September 23, 2002

DEFENSE NUCLEAR FACILITIES SAFETY BOARD

Staff Issue Report

SUBJECT: Safe Storage of Sodium Fluoride Traps, Oak Ridge National Laboratory

Figure 1: Pressure in the two monitored NaF/UF₆ traps, and temperature in Bldg 3019.

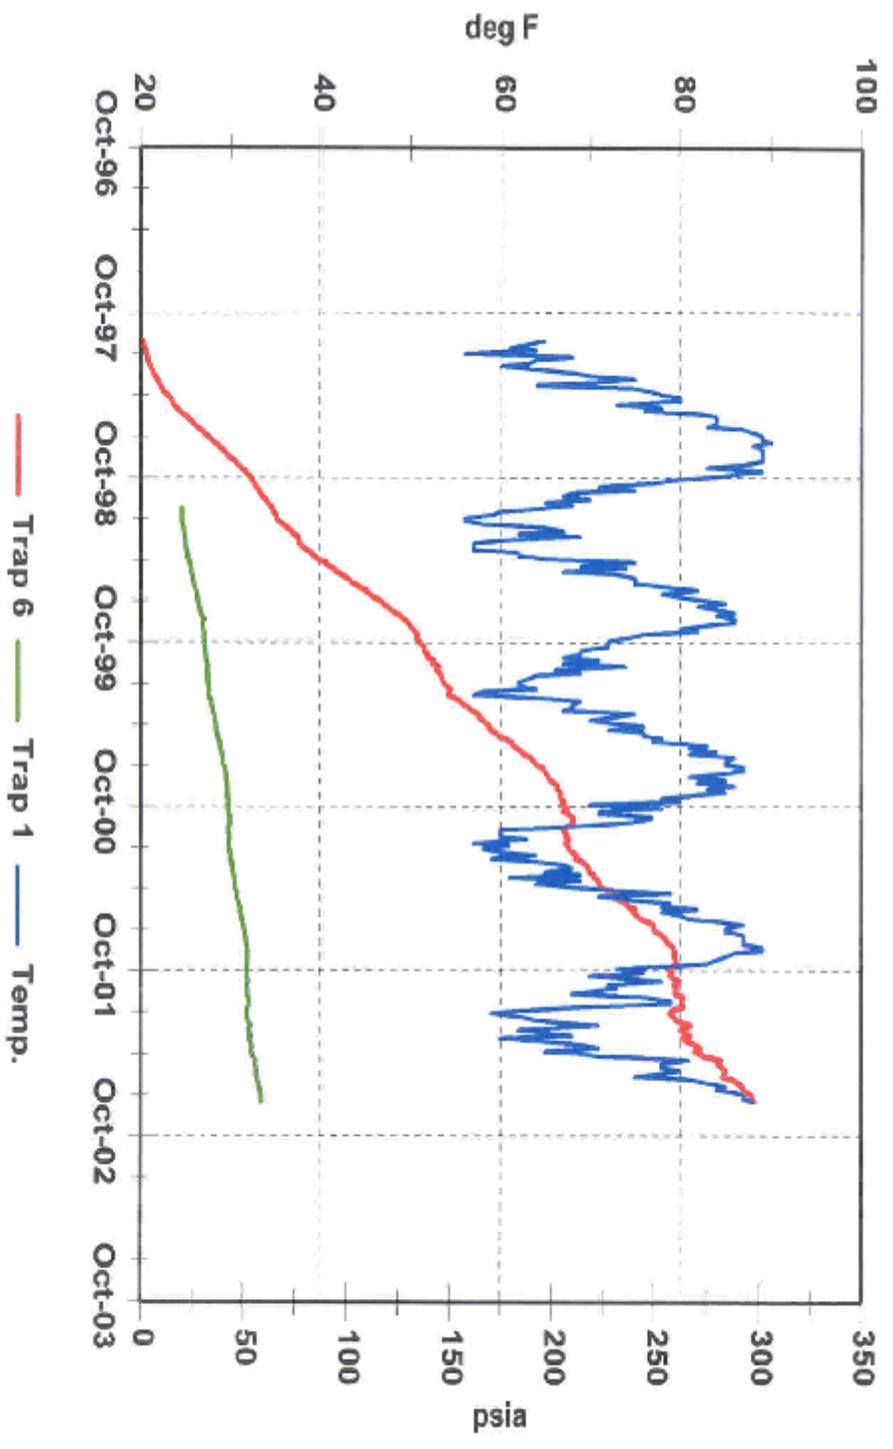
Radiolysis in NaF Traps and Pressure Monitoring. The internal pressure of the traps is increasing because of radiolysis of the NaF-UF₆ compound, which evolves fluorine gas. ORNL monitors the pressure in two traps (traps #1 and #6) stored in Cell 1 of Building 3019A. Figure 1 (attached) presents pressure data provided to the Board's staff by ORNL. The figure shows that the pressure in trap #6 is approaching 300 psig and is continuing to increase. Trap #1 contains considerably less material and has generated less pressure.

The pressure instrument is calibrated for pressures up to 250 psig. Therefore, ORNL is now estimating the pressure for trap #6 based on extrapolation of the calibration data, contrary to industry standards for calibration. Hence, uncertainty exists in the pressure measurements, and this uncertainty will increase as the pressure continues to rise above the calibrated range of the instrument. Furthermore, trap #6 is not believed to be the worst-case trap; thus higher pressures are expected to exist eventually in nine traps stored in the Building 3019A tube vaults. At this time, only one other trap is calculated to have a higher pressure than trap #6.
